Southeast False Creek (SEFC) City Lands Official Development Plan (ODP) Proposal

Professional Urban Design Workshop - June 17, 2003

GENERAL THEMES
Staff Summary

Building Patterning & Typology

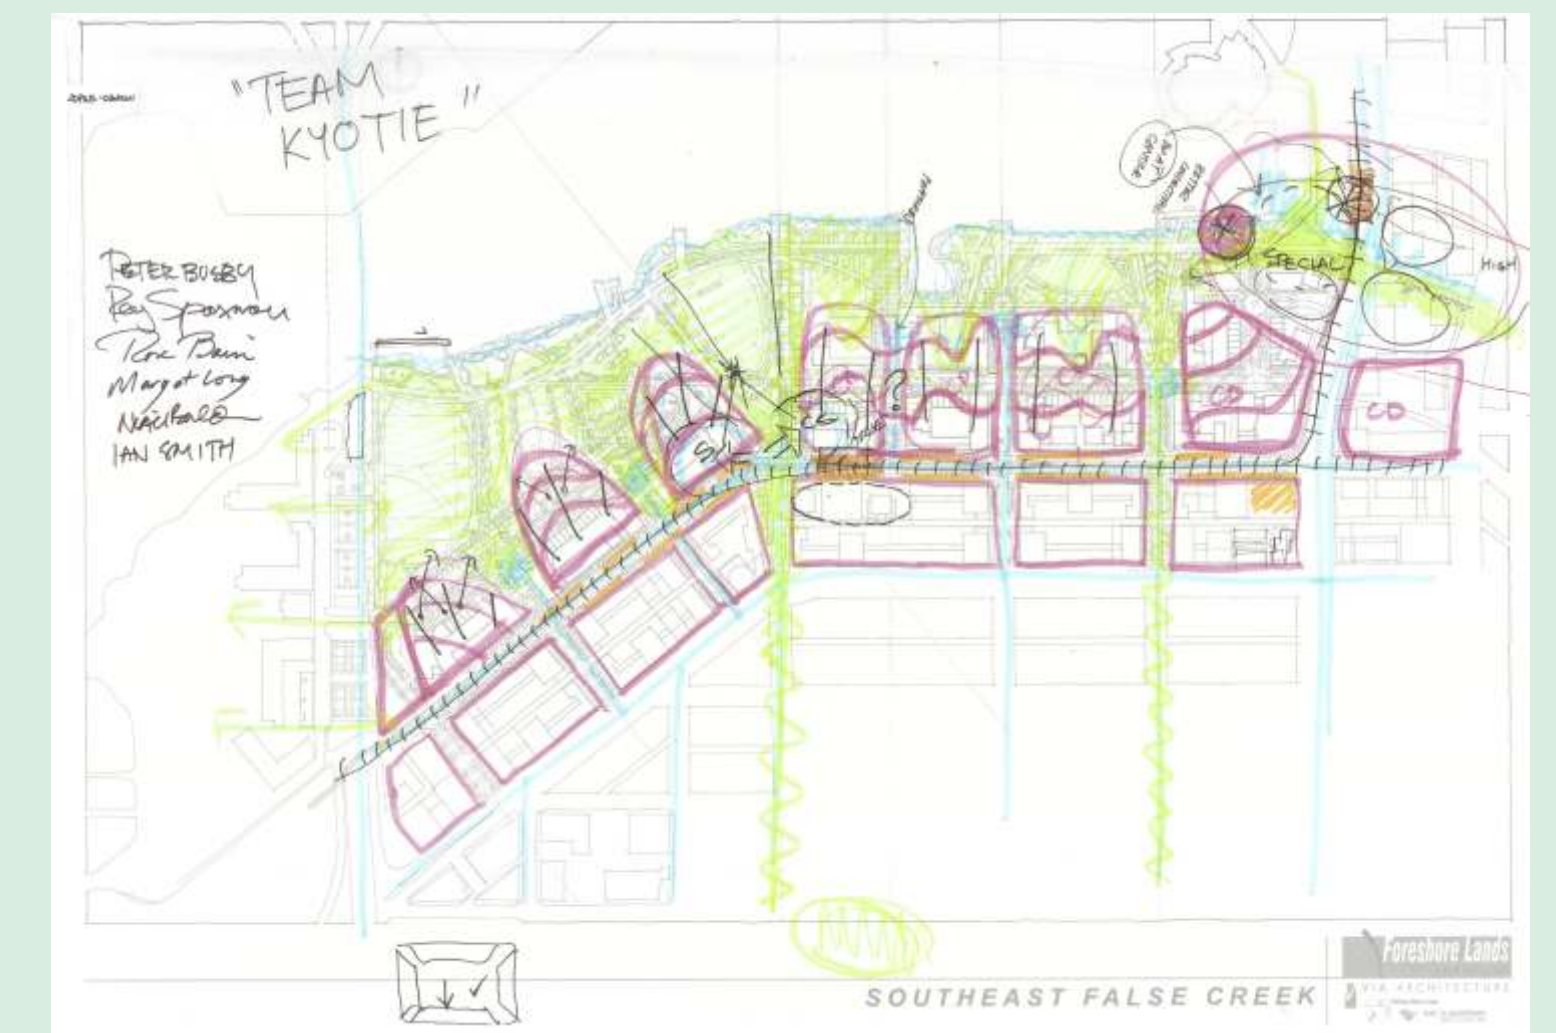
- The overall density target for the site is supported, but generally the Proposal shows a built form and patterning of density that is very typical in Vancouver i.e. tower and podium form.
- The Proposal needs to be better integrated with built form proposed for the Private Lands and other surrounding communities.
- The design currently splits the site into two areas the East and the West neighbourhoods. The focus should be on creating distinct districts through the patterning of density and open spaces.

- Consider patterning that breaks down the large-scale parcels and allows for smaller and medium scale development at least in portions of the site.
- Consider a patterning that creates greater height contrast between the east and west areas.
- Consider how massing can be used to frame open space, entrances, and linkages of the site and the surround.

Linkages to Surrounding Areas

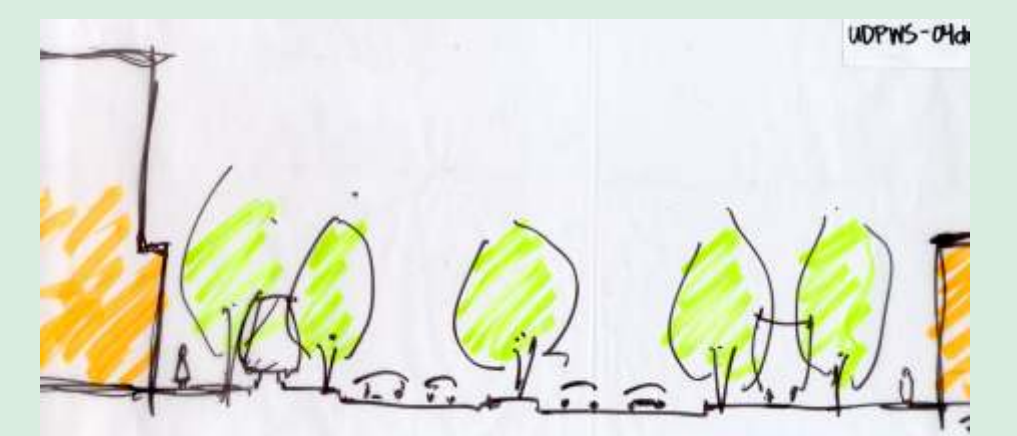
- Linkages to surrounding areas need further consideration.

- Consider a bolder linkage to the Flats on the east side of the site via Central Valley Greenway.
- Consider a bolder emphasis of the north-south streets as green connections to the Mt. Pleasant neighbourhood area and the water.
- Secure an Ontario Street greenway connection with community centre at Main and 7th Avenue.
- Consider 2nd Avenue street as part of a 'Great Street Network' connected to the North Side of False Creek (i.e. consider treating as a necklace extension of the 'Great Street' design of Pacific Boulevard). The street design of 2nd Avenue needs serious consideration.

Waterfront

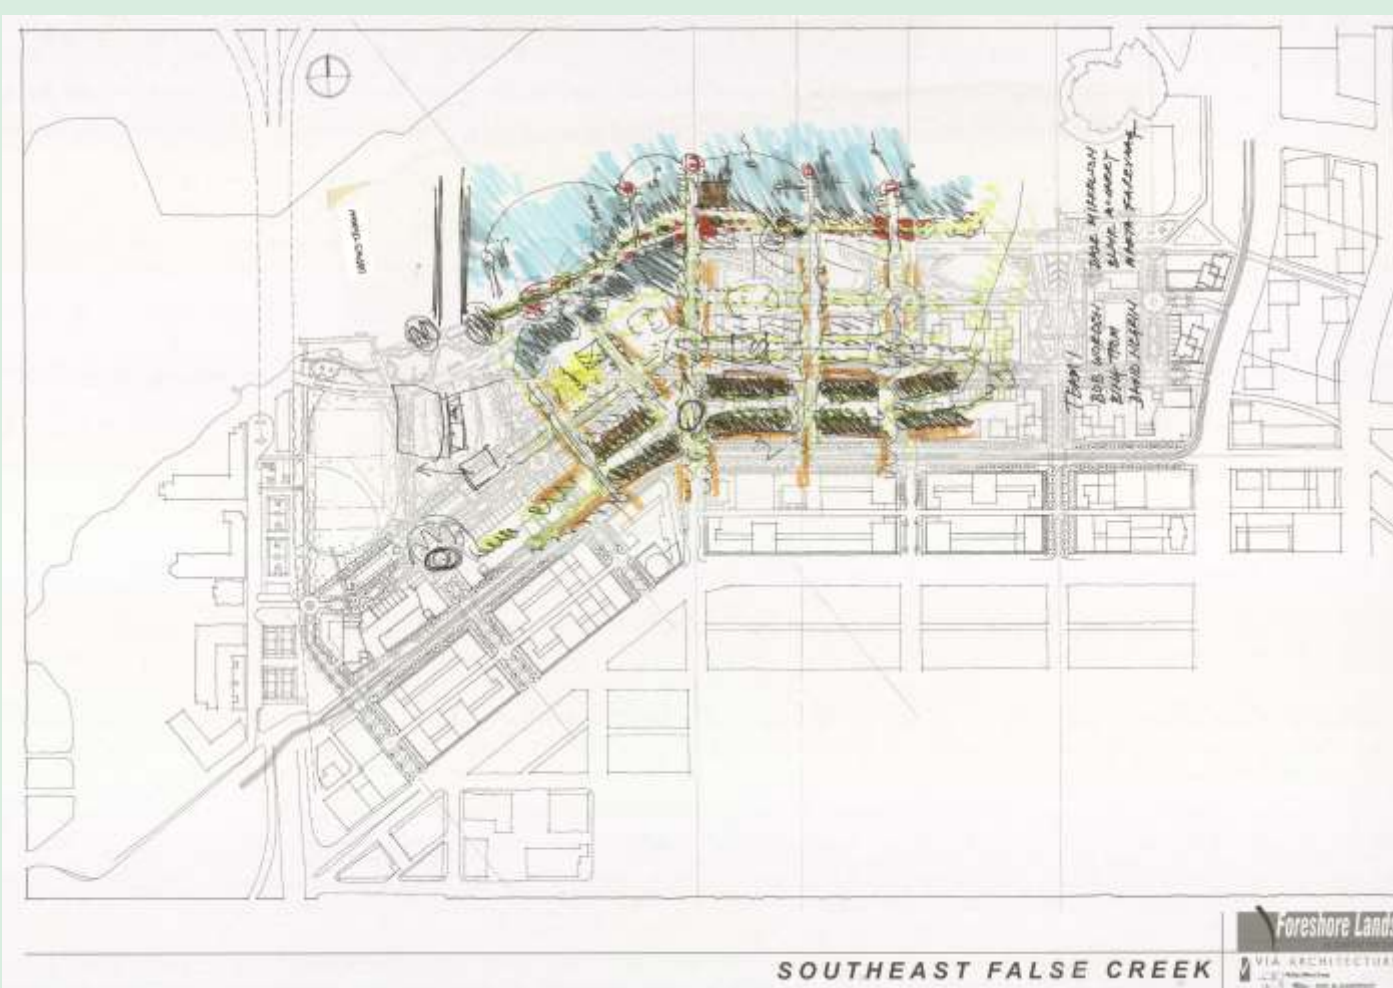
- The Waterfront Walkway character on this site needs to be more distinctive and in contrast to other parts of the walkway in Vancouver.

- Consider ways in which to engage people on the water's edge, for example, more docks/piers on water.
- Consider how to further integrate facilities for non-motorized boating and water sport and increase accessibility of the water's edge.
- Consider commercial uses along the walkway to create a different character from other parts of Vancouver, including restaurants, bars, other commercial opportunities and/or public courts to create a different character.

Park

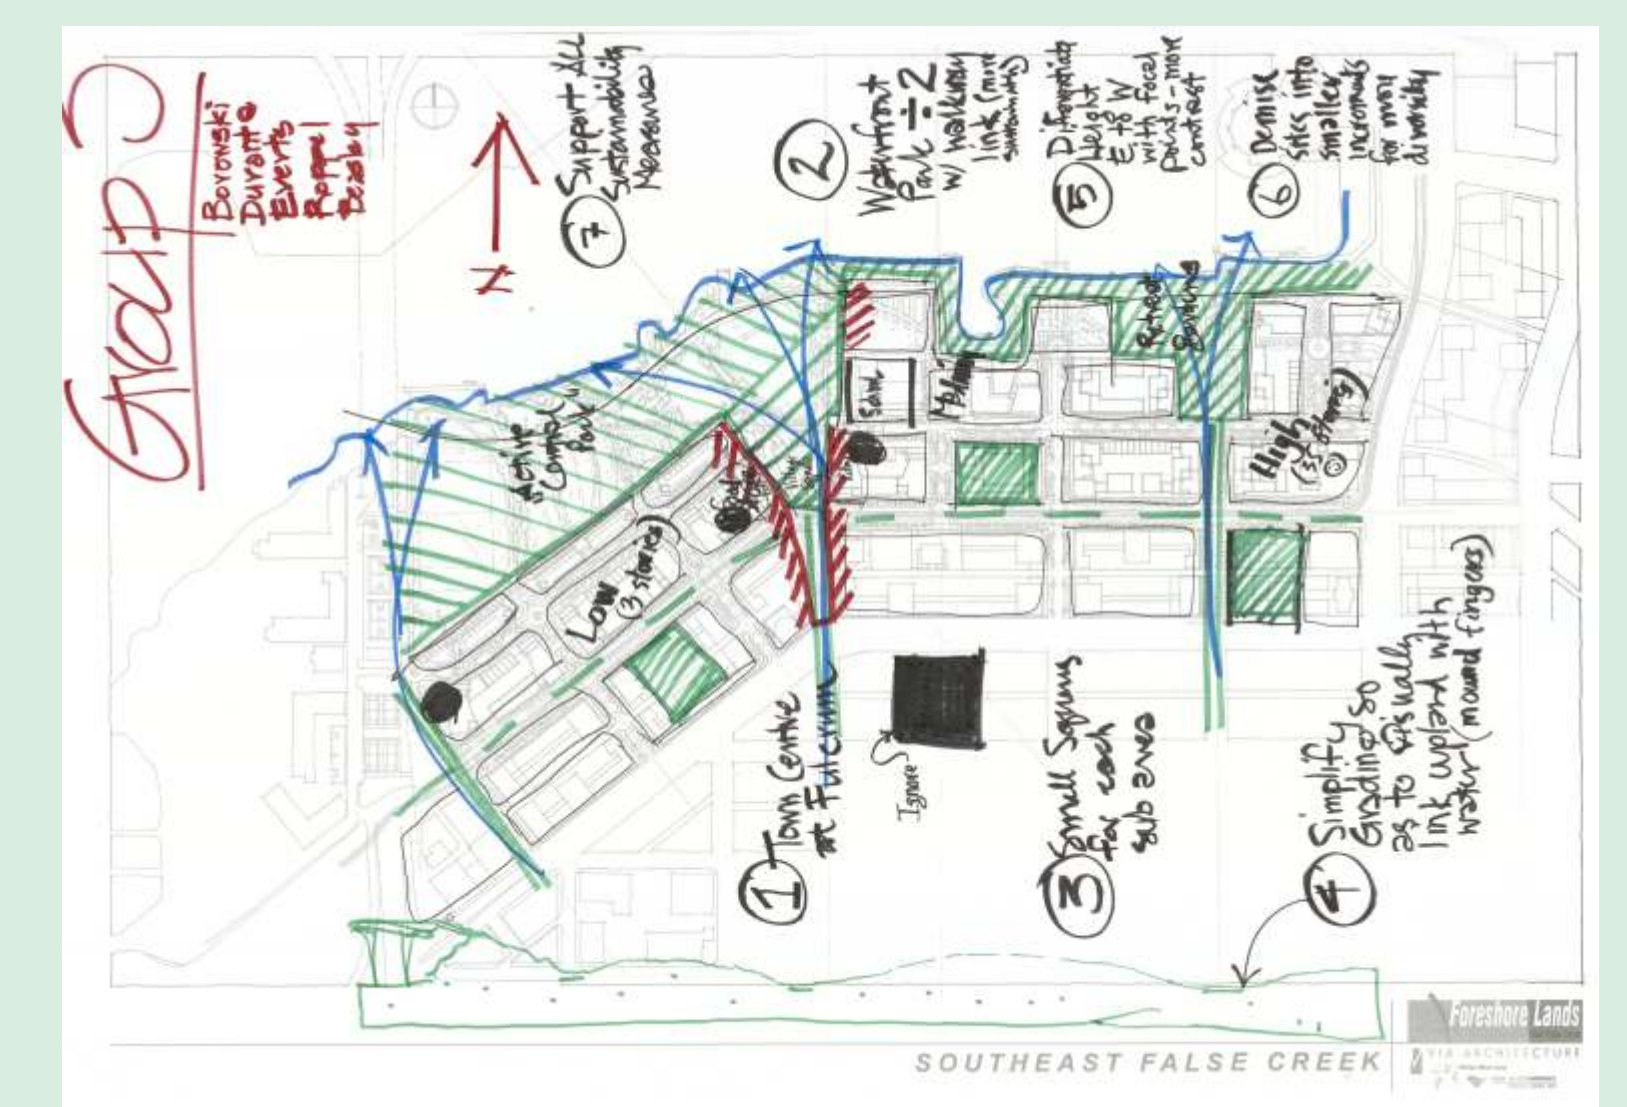
- The Proposal appears to separate the built environment from open spaces and needs to be better integrated.

- Consider breaking down the scale of the park, especially on the west side, and moving smaller parks into the neighbourhoods (i.e. quality small block size parks, with considered relationships with housing, other uses) to create district character.
- Consider creating a more generous park area on the east side, where higher density sites are proposed.
